**SUBJECT:** Case No. IPC-E-23-23 Idaho Power Company's 2023 Integrated Resource Plan

BEFORE THE IDAHO PUBLIC UTILITIES COMMISSION

COMMENTS OF GOLDENDALE ENERGY  
STORAGE PROJECT ON IDAHO POWER  
COMPANY'S 2023 INTEGRATED  
RESOURCE PLAN

RE: Comments on Idaho Power IRP Case No. IPC-E-23-23

**Figure 1: Reduction of nation-wide capacity requirement by deploying GHPs.**

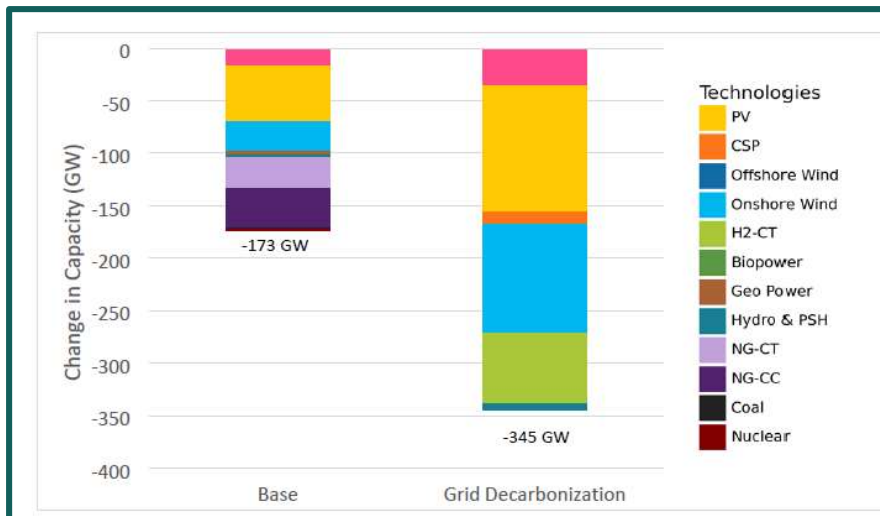
Figure 1<sup>3</sup> shows the large capacity reduction across the country for the two scenarios of “Base” (business as usual) and “Grid Decarb” (95% grid CO2 reduction by 2035).

There are two reasons why GHPs cut demand even as they electrify heating.

1. Summer peak for A/C is reduced by up to 50% by using cool water instead of hot air.
2. In heating mode, GHPs operate at up to 500% efficiency (5 units of building heat for 1 unit of electricity). Consequently across the system, the grid peak winter electrified heating load is smaller than the current summer air-cooled summer peak load.

This suggests that GHPs are a cost-reduction technology for the existing grid and for efforts to achieve a decarbonized grid in the future, which is an Idaho Power objective on behalf of its ratepayers.

**Figure 2: Reduction of nation-wide marginal cost of electricity by deploying GHPs.**

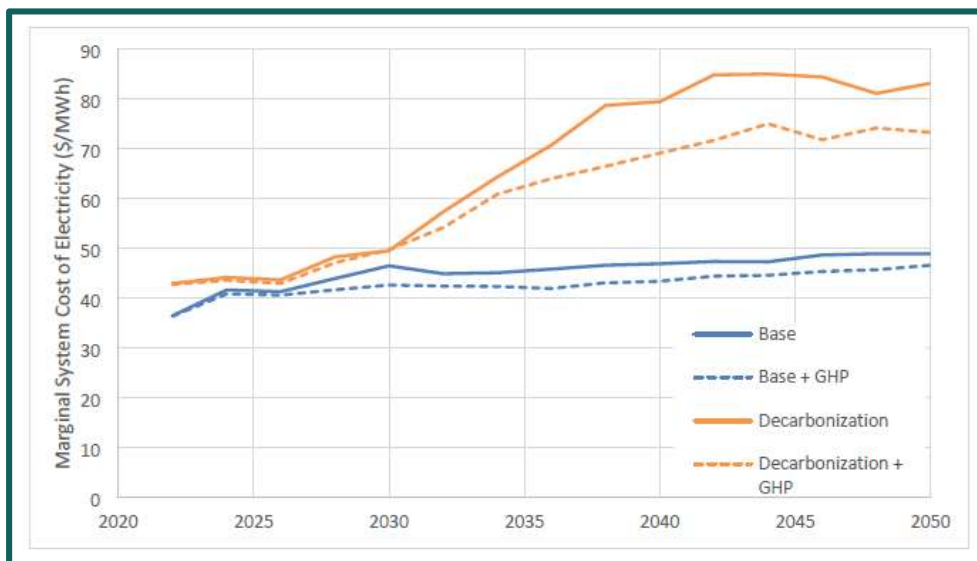
Figure 2<sup>4</sup> shows that GHPs reduce the marginal cost of power (roughly wholesale cost of power). This includes not only the benefits of less new capacity, but also reduced expensive summer peak power.

One important element of Figure 2 is that this study forecasts a nationwide increase in the cost of power for decarbonization (solid blue line to solid orange line). However, the dashed orange line is the cost that results for decarbonization with GHPs and it shows that the cost of decarbonizing the grid can be cut by >30% by using GHPs.<sup>5</sup> This is a highly relevant result for Idaho Power and its ratepayers and shows that encouraging the adoption of GHPs, where appropriate, can lower the cost of power on the grid for everyone. GHPs may be a unique renewable energy resource in that way.
